EXTERIOR ELEVATIONS  
SCALE: 1/4" = 1'-0"

THE 1826 MODEL DESIGN FOR:  
**YASMANIS REYES**  
PROJECT ADDRESS: 188 SW BIRCH GLEN LAKE CITY FLORIDA 32024

**DIMENSIONED FLOOR PLAN**

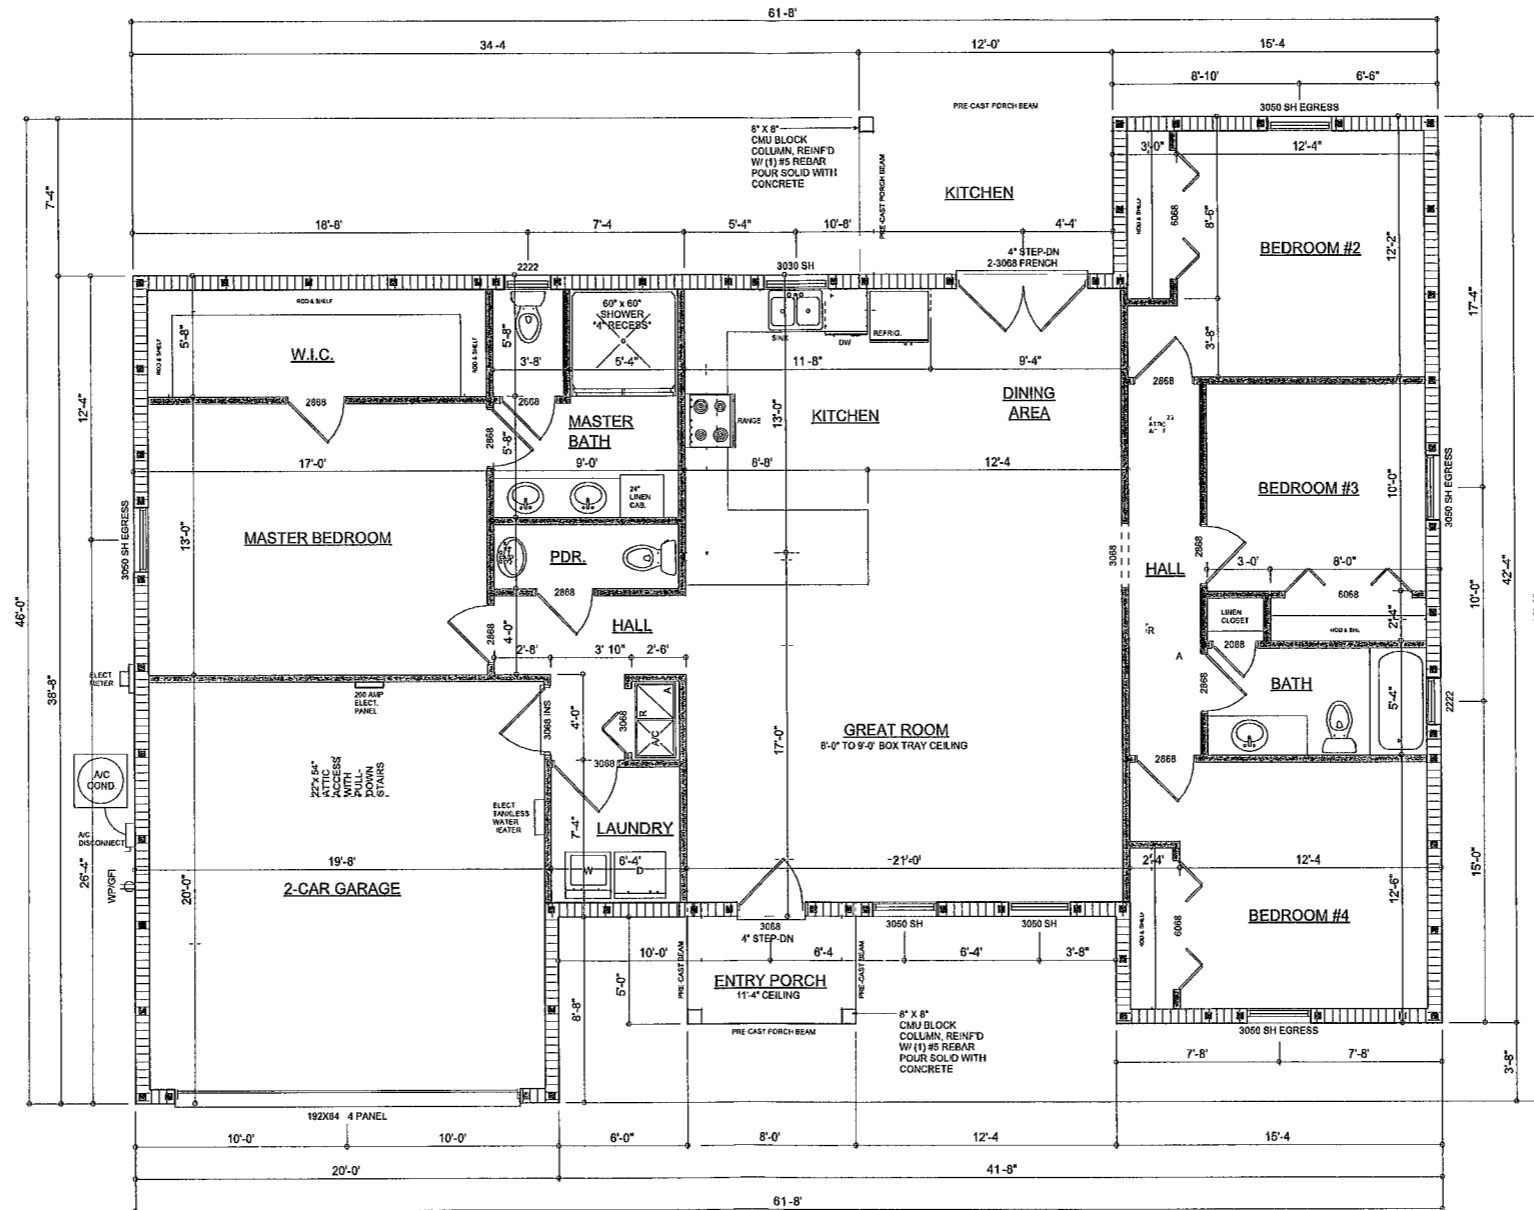
File  
COPY  
Flipped plan  
Floor plan  
OK J.C.  
5.16.25
